ADDENDA 2

Subject: Bid 19-012, Construction of Employee Fitness and Wellness Center for the County of El Paso

BRIDGE

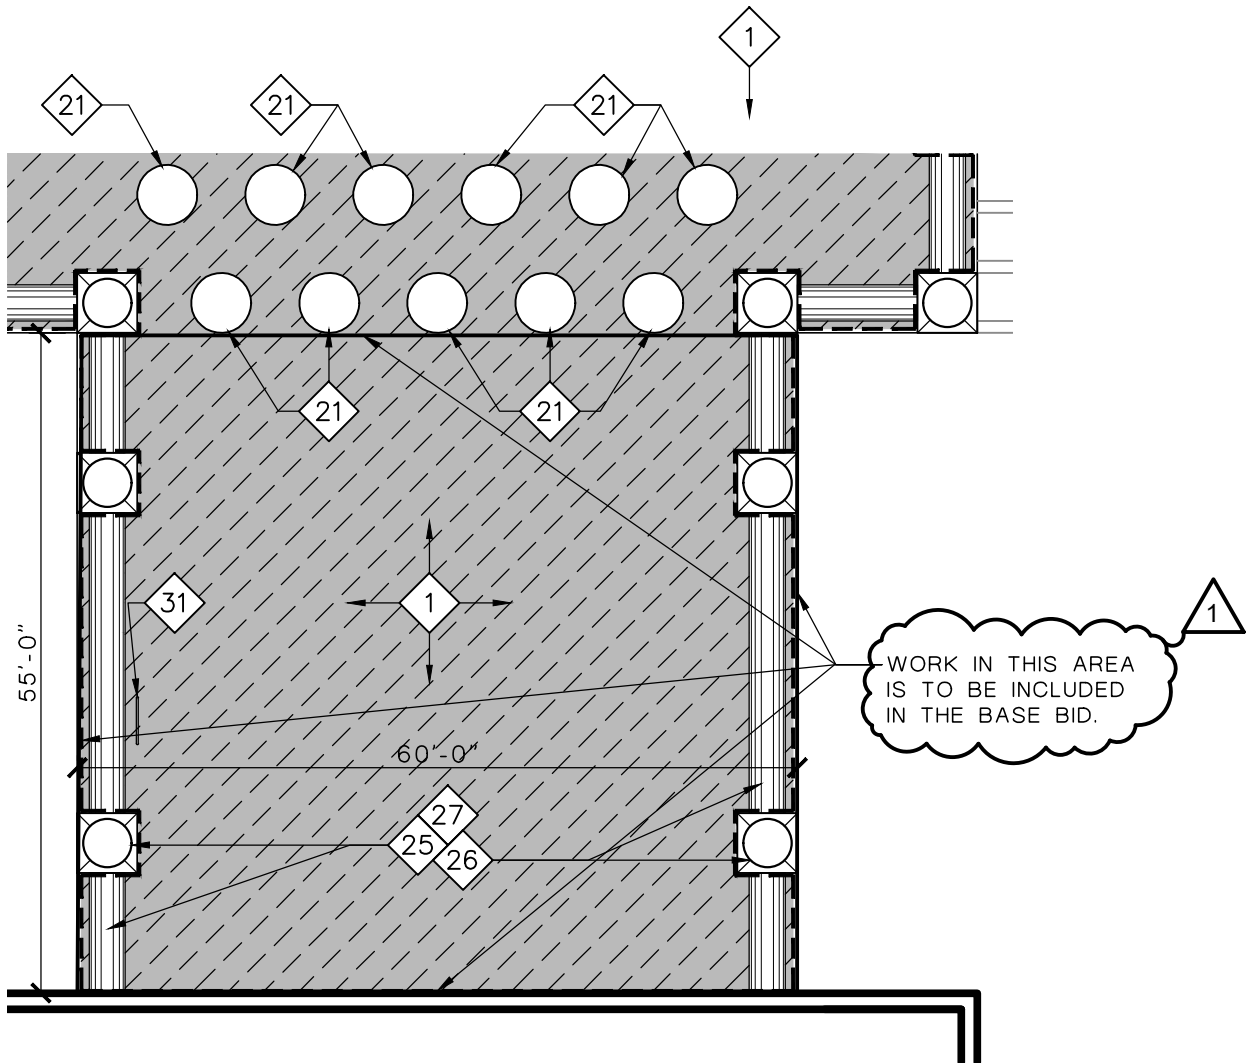
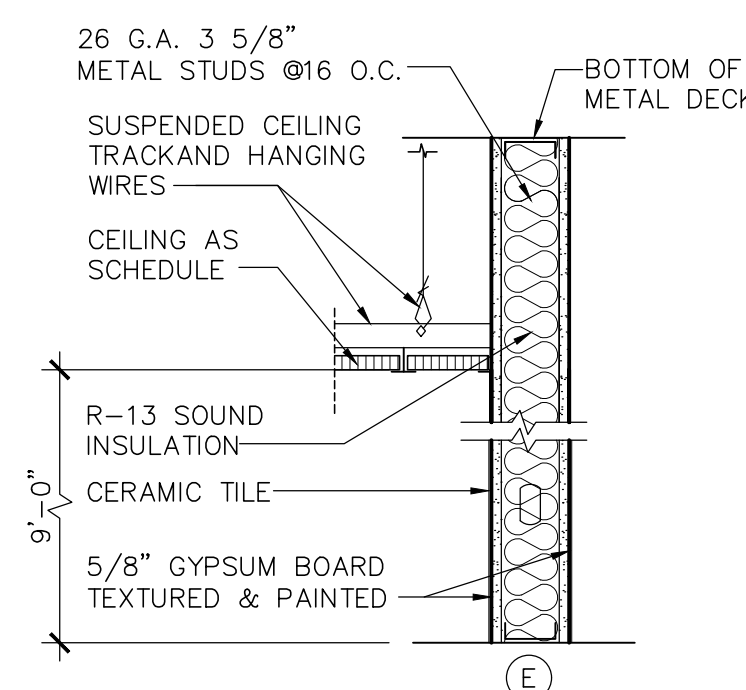
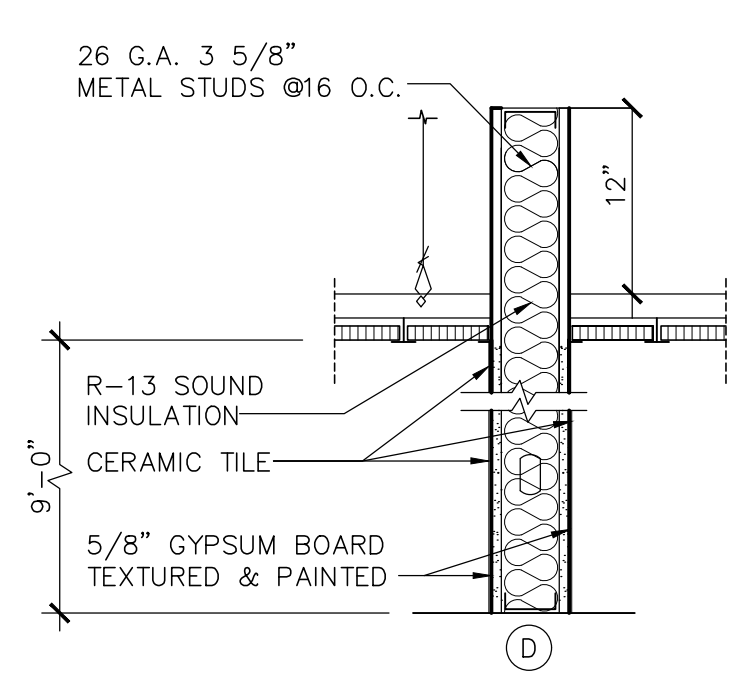
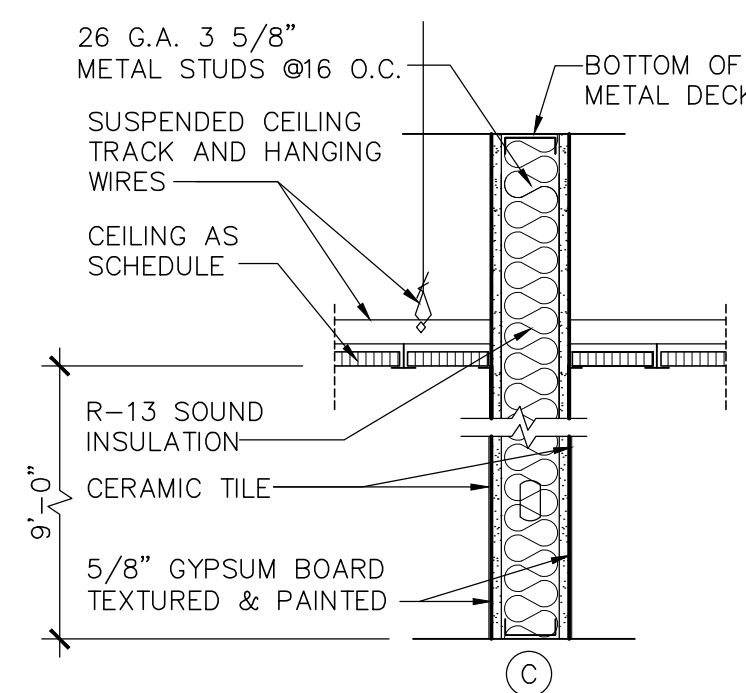
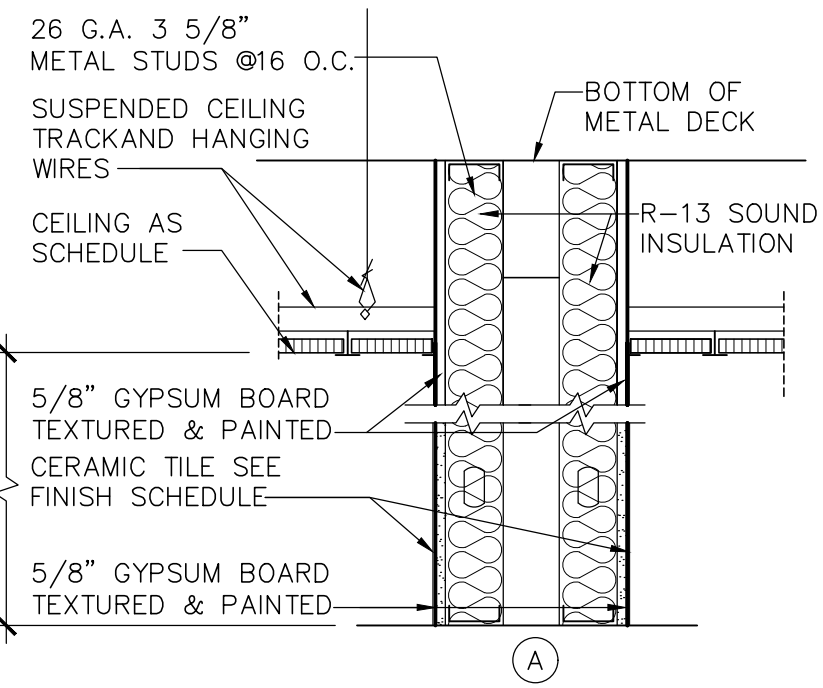
3. Sheet A1.0 - Existing/ Demo sidewalks – Clarification
 - All work indicated on this sheet shall be considered as part of alternate No. 1 with the exception of the walkway bridge over the fitness center remodel. This work shall be included within the base bid. - See detail 1 bridge issued attached.

1 REVISED LOWER LEVEL ENLARGED PLAN
GYM 5,125 SQ. FT.
SCALE: 1/4"=1'-0"

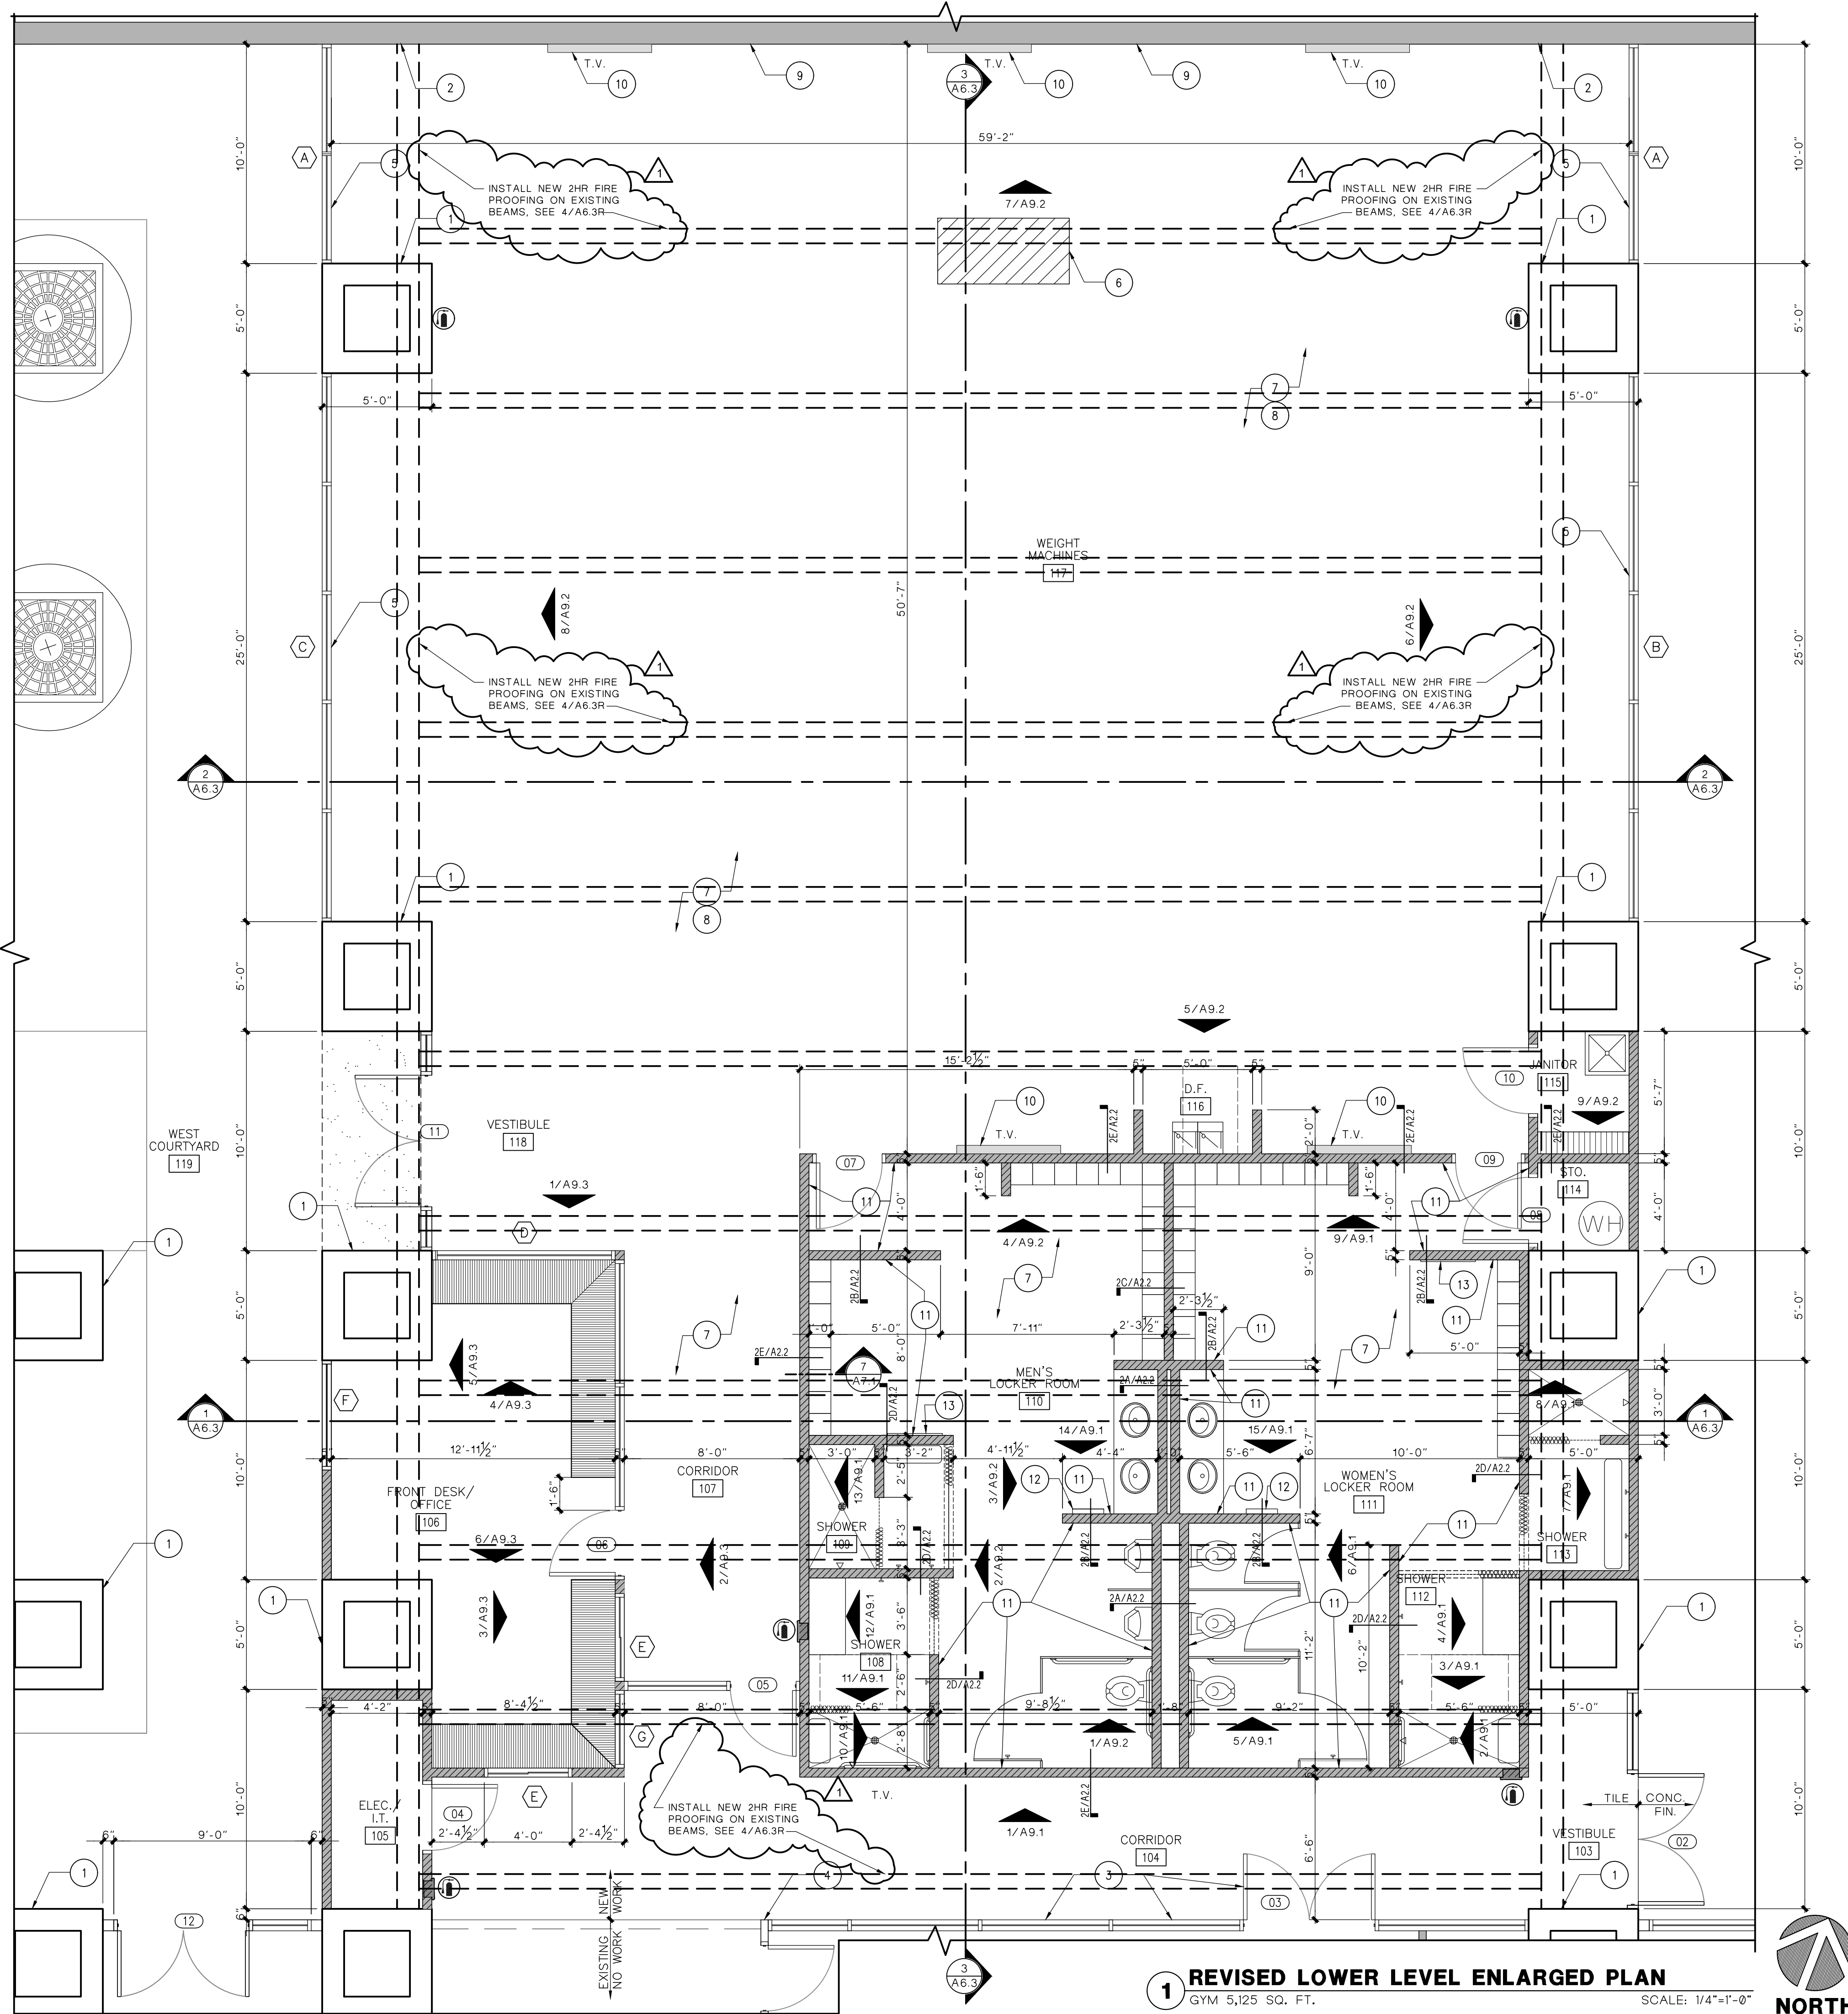
8. Sheet A2.2 and A4.1- Fire Rated Beam
 - Sheet A2.2R and A4.1R are reissued to show location and length of fire rated beam enclosure. See detail 4/A6.3R Fire Rated Enclosure.

4 BEAM FIREPROOFING SCALE: 3/4"=1'-0"

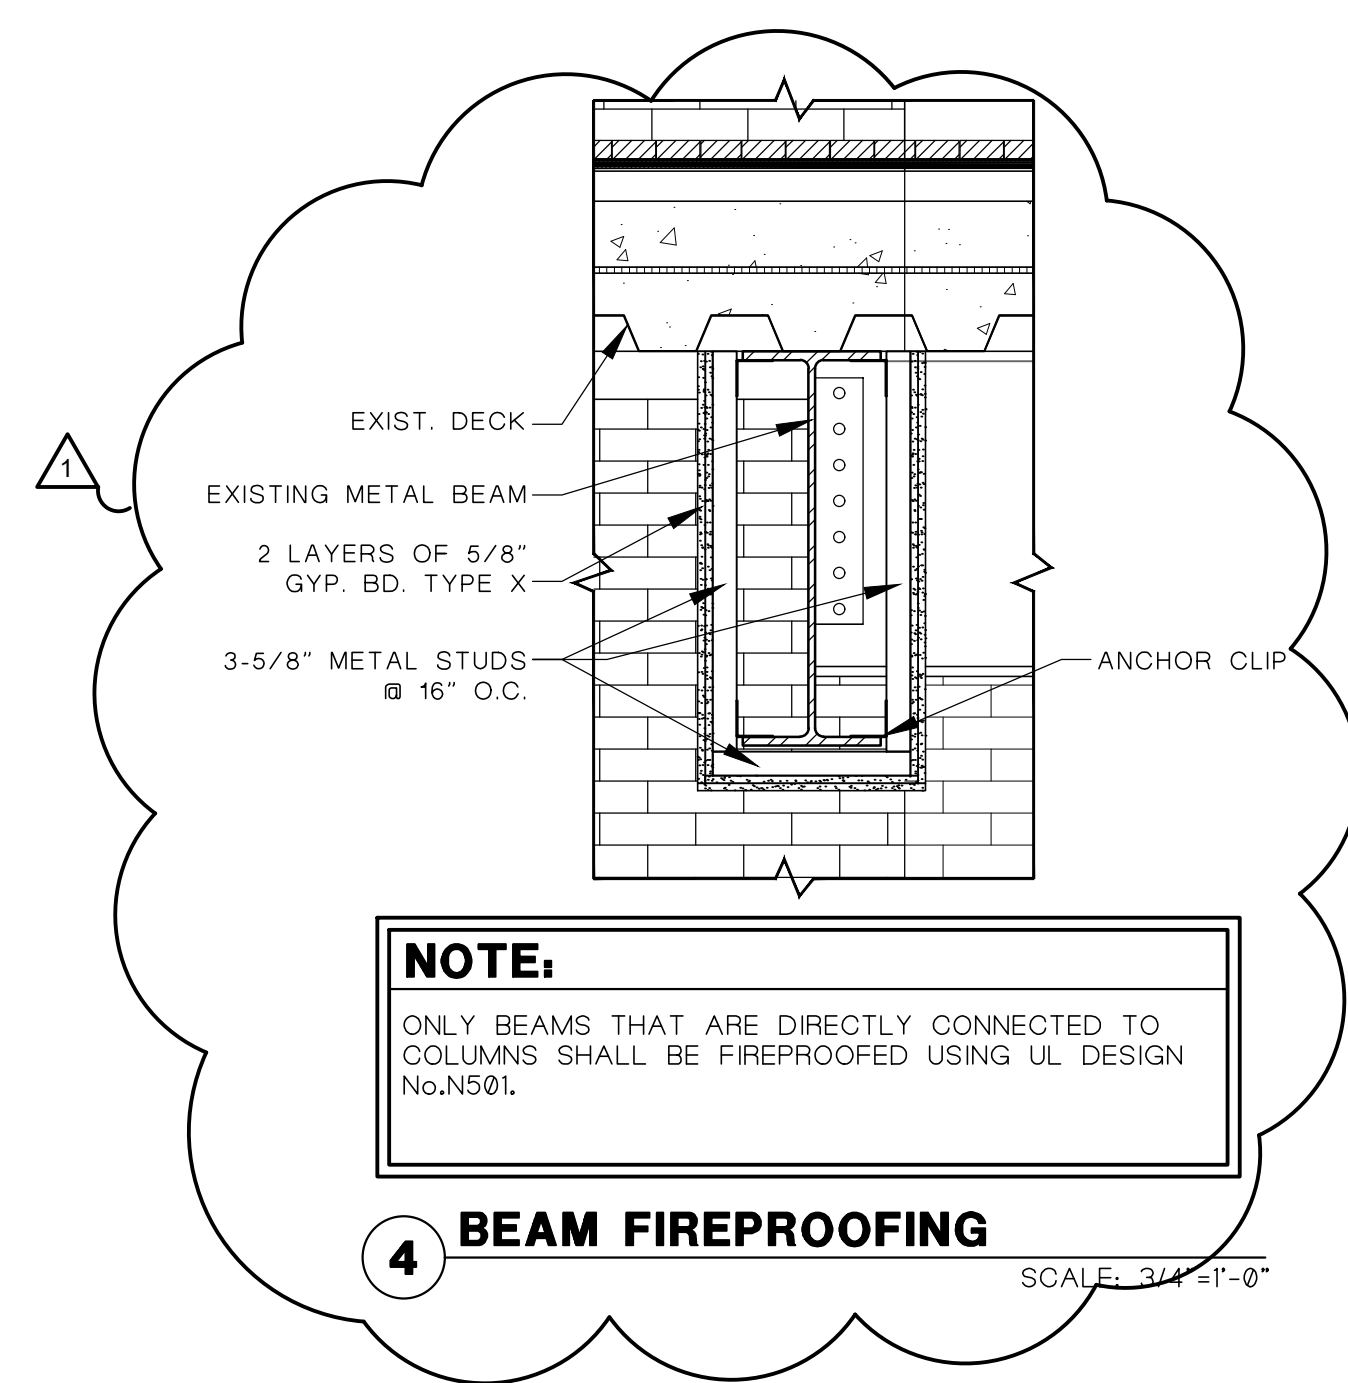
- Mosa Tile USA
 - Terrace Tile - Mosa XT
 - Terra Grey # 225 and 227
 - Anti-slip 24" x 24"
10. Sheet A6.3R - Building Sections
 - Sheet A6.3R has been modified to show new fire rated beam location and detail 4/A6.3R.

NOTE:
 ONLY BEAMS THAT ARE DIRECTLY CONNECTED TO COLUMNS SHALL BE FIREPROOFED USING UL DESIGN No.N501.
